INTERIOR RENOVATIONS

**HARTRANSIT
62 FEDERAL ROAD
DANBURY, CT 06810**

S/P+A PROJECT NO. 21.155

DATE: January 30, 2023

1 POWER PLAN - LEVEL 1
1/4"=1'-0"

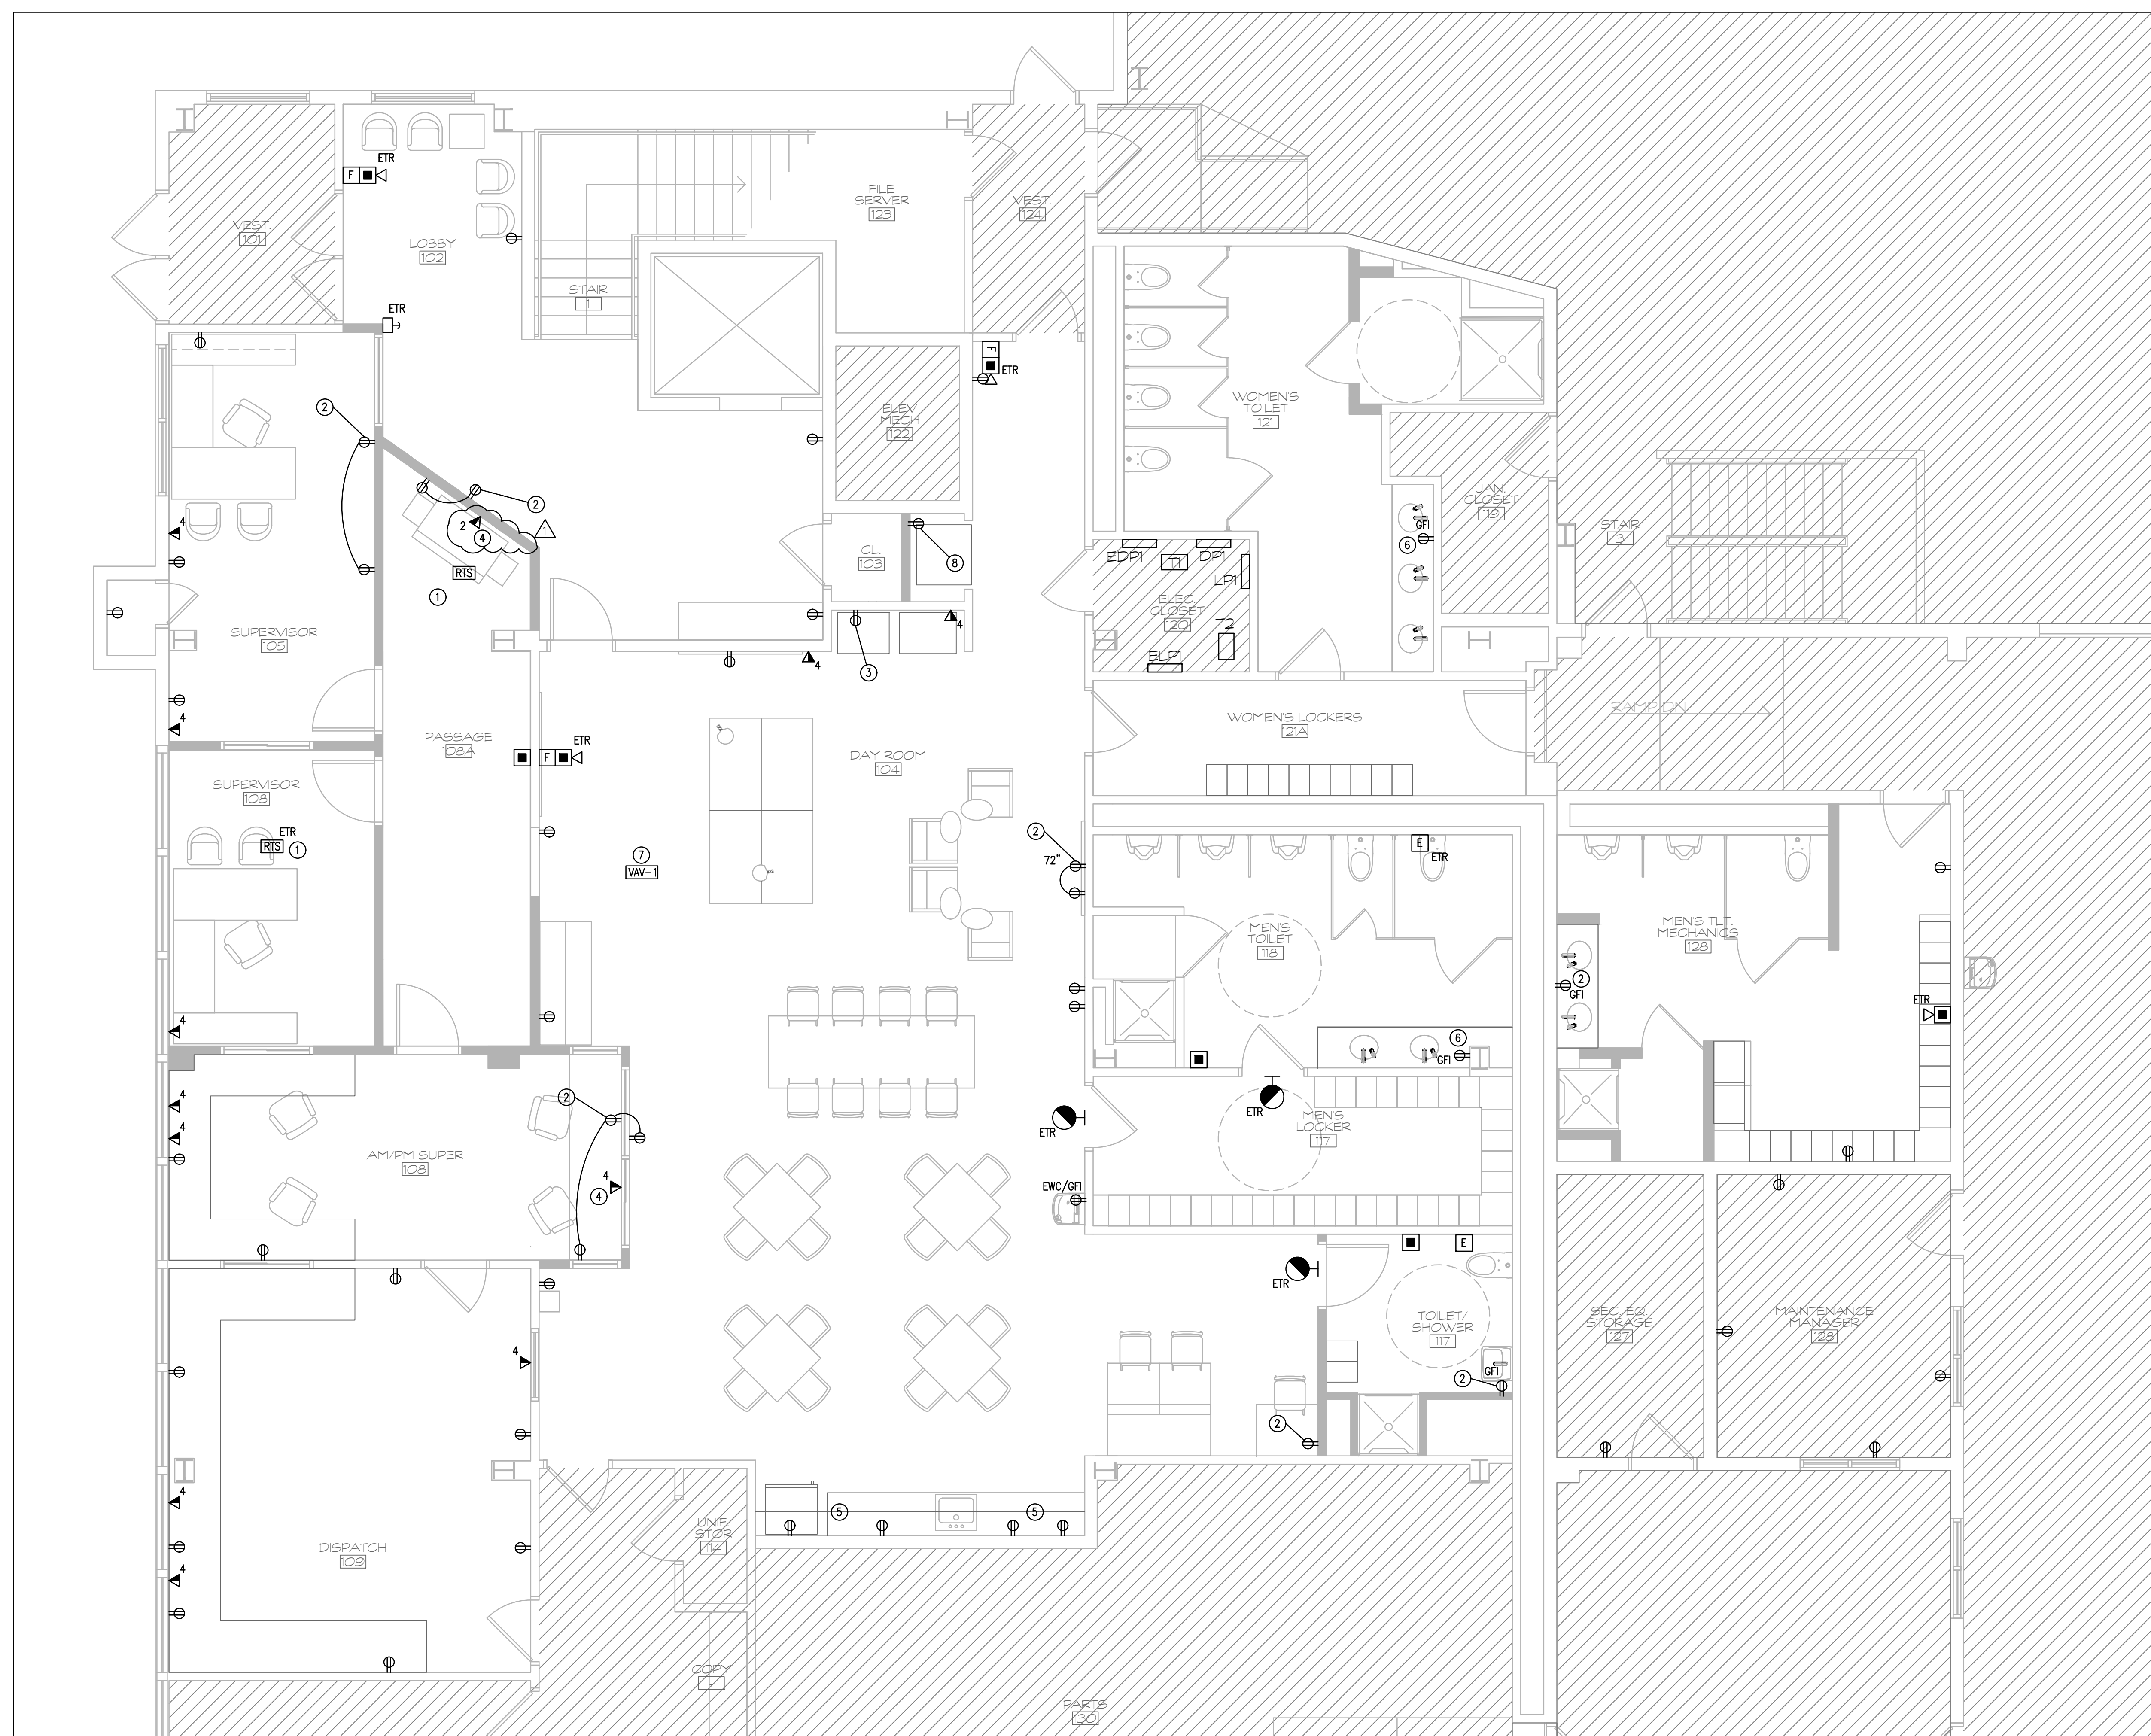
- DRAWING E121, POWER PLAN – LEVEL 1, has been deleted in its entirety. A new Drawing E121, POWER PLAN – LEVEL 1, has been added and is attached as part of this addendum*(1).

042	Prints do not specify any WAP locations?	01/25/23	Correct.	3
043	E121 Passage Area shows a network printer with power, no data there for connectivity?	01/25/23	Refer to Addendum #3 for revisions.	3
044	E122 Boardroom large table, no data under table?	01/25/23	Correct.	3
045	Specifications call out for duct leakage and cleanliness testing (233113-13). Is the mechanical contractor responsible for duct leaks found in the existing duct system? Also, would we be required to clean the existing ducts if not within specifications?	01/25/23	Mechanical contractor would be responsible for leaks and cleaning of only new work.	3
046	Does the existing HVAC system need to stay in operation during construction?	01/25/23	Yes.	3
047	Are signed and sealed design calculations by a professional engineer required for new duct hangers on this project?	01/25/23	No.	3
